Appendix G. Consultation Comments

National Park Service (NPS) Regional Haze SIP feedback for the Minnesota Pollution Control Agency

July 11, 2022

Minnesota Regional Haze Plan - Technical Comments

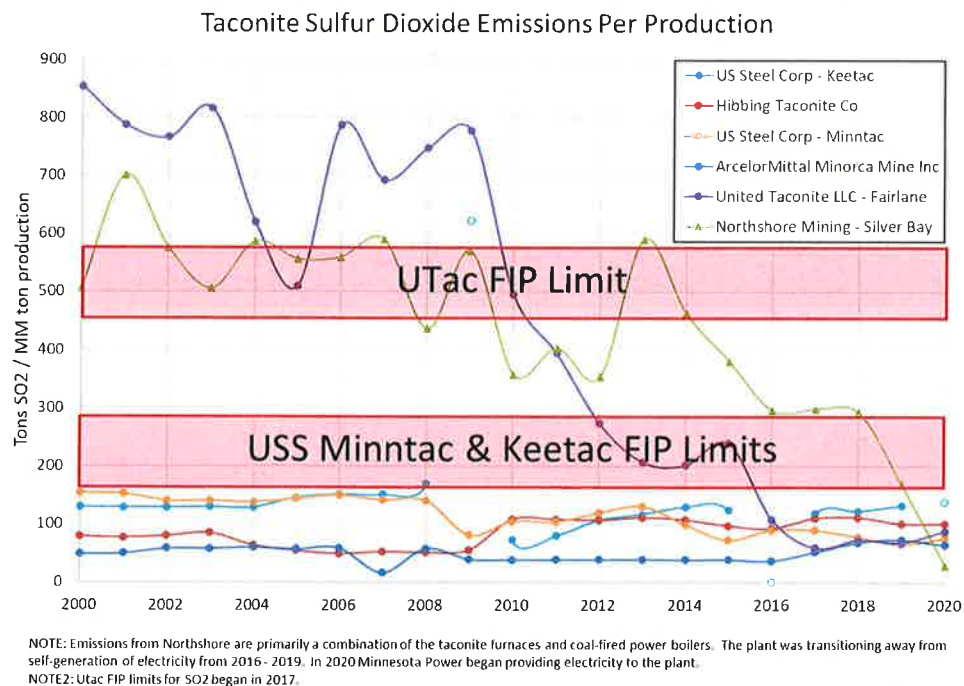
- As mentioned previously, we are very interested in the Administrative Order (AO) associated with the idling of the two power boilers at Northshore Mining. We have not seen the language in this agreement and are particularly interested in sections associated with a possible restart. To comply with the Regional Haze Rule we feel that prior to any restart, the installation of the emission controls identified in the plan for these boilers (see subsequent section of this letter) should be installed. We are concerned that under the terms of the AO the facility may submit an alternate operating scenario at a reduced capacity and use it to recalculate an artificially elevated cost effectiveness value of controls and thereby circumvent reasonable progress requirements. The cost effectiveness of controls has been determined to be reasonable in this SIP and does not need to be recalculated.

- Also, we feel it is important that any future change in the AO needs to go thru public notice and comment. We have seen AOs in the past contain a requirement to submit analyses/plans/reports for State review and this turns into an unending cycle of submit, review, repeat – all outside of FLM and public review and comment. This path could serve to delay the application of Regional Haze requirements and even potentially avoid them entirely depending on the ultimate decision of your agency at some future time.
